**LOT 1
VILLAGE DRIVE
SUBDIVISION**

**SITE PLAN &
REVISION
EXHIBIT**

C2

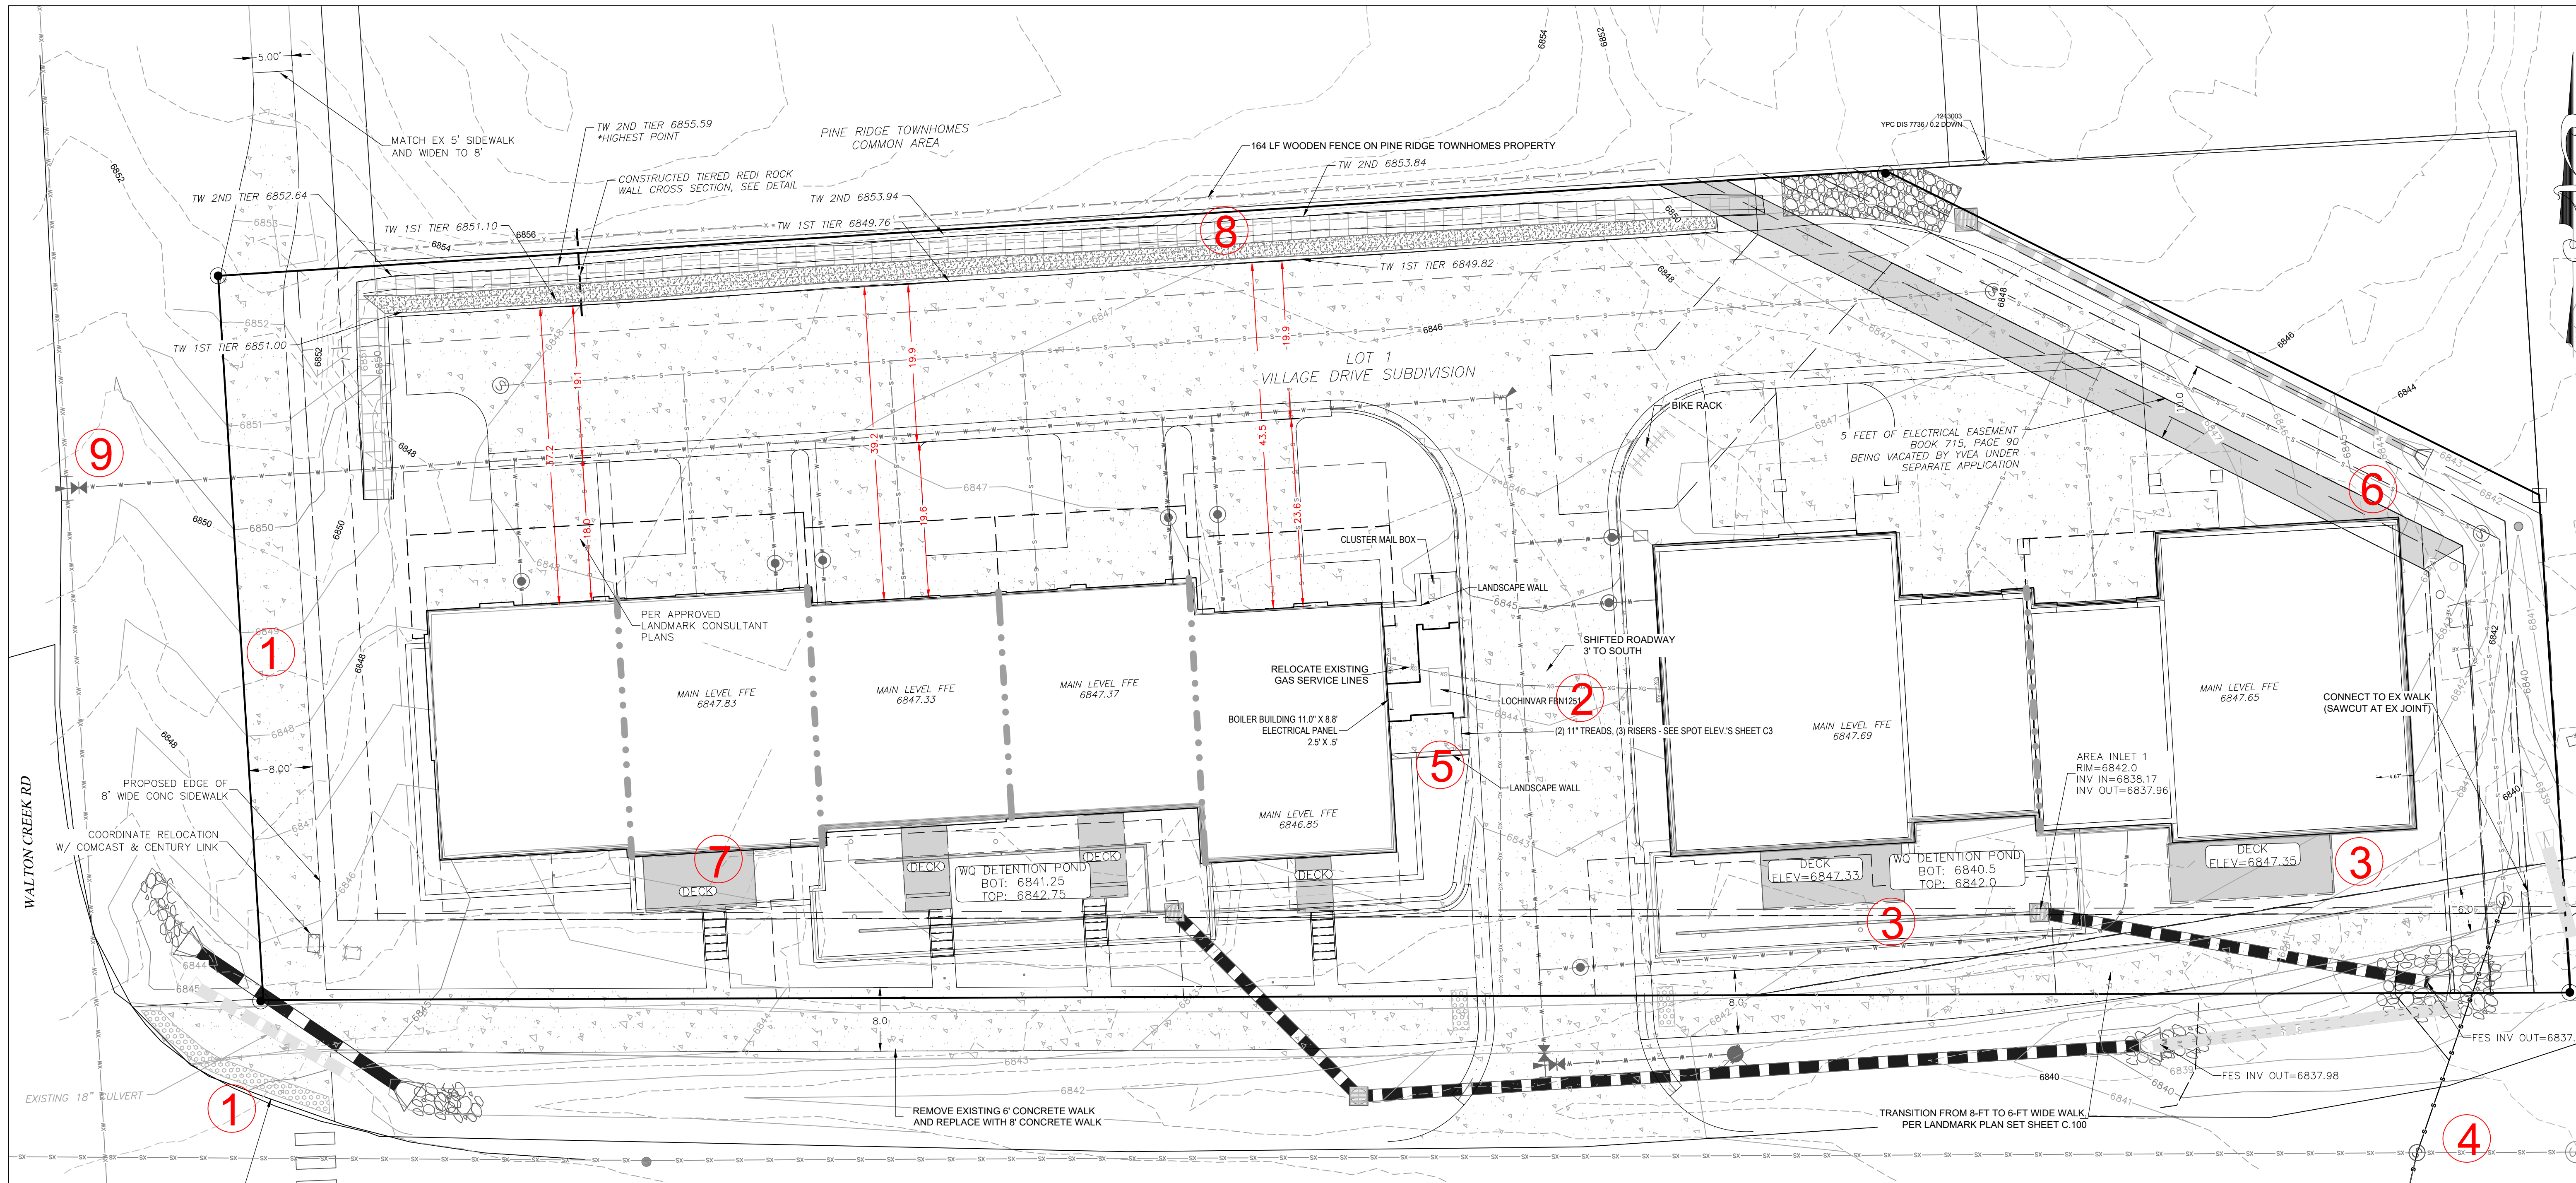
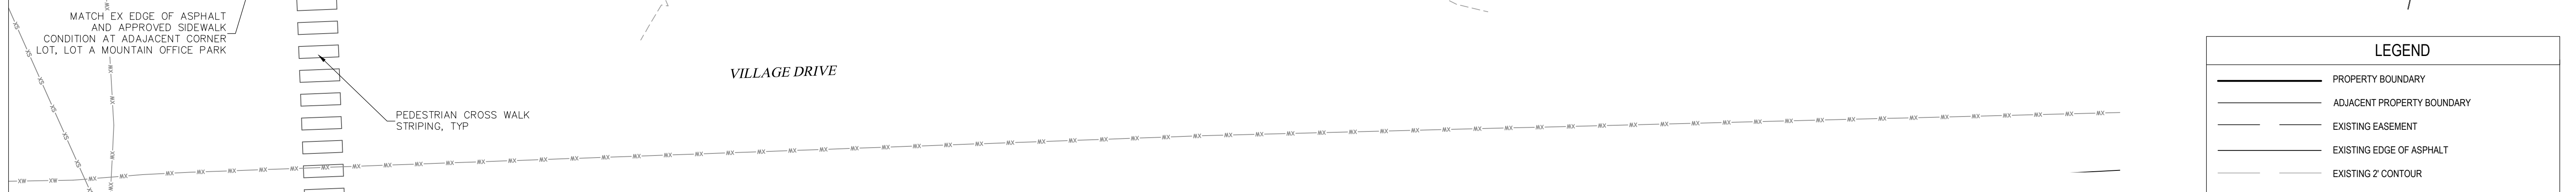
- ① MODIFIED SIDEWALK ALIGNMENT ALONG WALTON CREEK ROAD AND MODIFIED CONNECTION AT SOUTHEAST CORNER OF WALTON CREEK ROAD AND VILLAGE DRIVE
- ② SITE ENTRANCE ON VILLAGE DRIVE SHIFTED 3-FT SOUTH AND BUILDING SHIFTED 4.8-FT SOUTH
- ③ REMOVAL OF STAIRS AND SIDEWALK FOR BUILDING ACCESS CONNECTION ALONG VILLAGE DRIVE
- ④ SANITARY SEWER REVISION, SEE SHEETS C5A AND C5B
- ⑤ BOILER BUILDING AND CLUSTER MAIL BOX AND ASSOCIATED CONCRETE PAVING, LANDSCAPE WALLS AND STEPS
- ⑥ VACATION OF EXISTING ELECTRICAL EASEMENT
- ⑦ DECK DIMENSIONS
- ⑧ RETAINING WALL - AS DESIGNED AND CONSTRUCTED AND WOODEN FENCE ABOVE RETAINING WALL
- ⑨ WATER LINE REVISION, SEE SHEET C6
